APPLICATION FOR
CONSTRUCTION OF
PAVED
SIDEWALK/ DRIVEWAY

Driveway Review Form

Address: 262 Union St

Permit Notes (Prop. Work): Re-paving existing parking lot and redo curb and sidewalk in bad condition.

Driveway Review

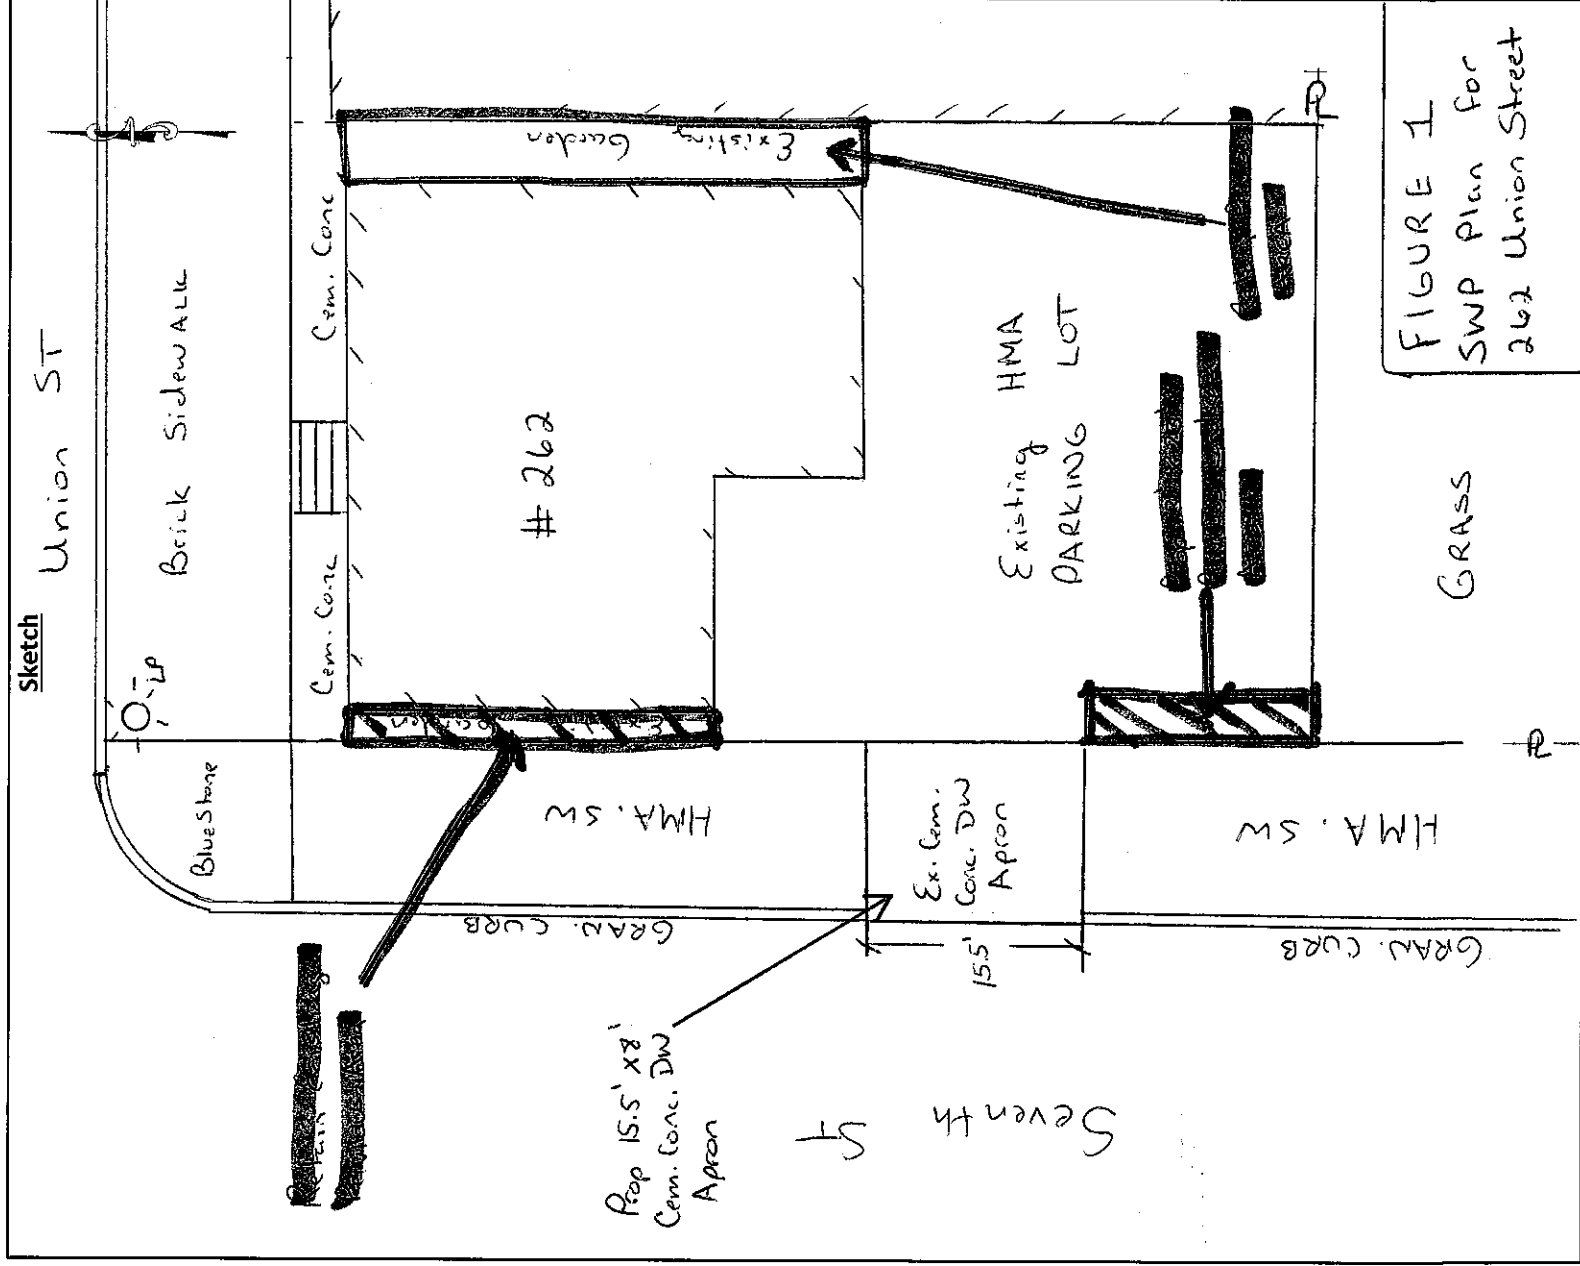
Additional Inspection Notes: 1. Must comply with SWP Response letter. 2. Remove existing 15.5'x8' cem.conc.DW apron. 3.Install new 15.5' x 8' cem.conc.DW apron.
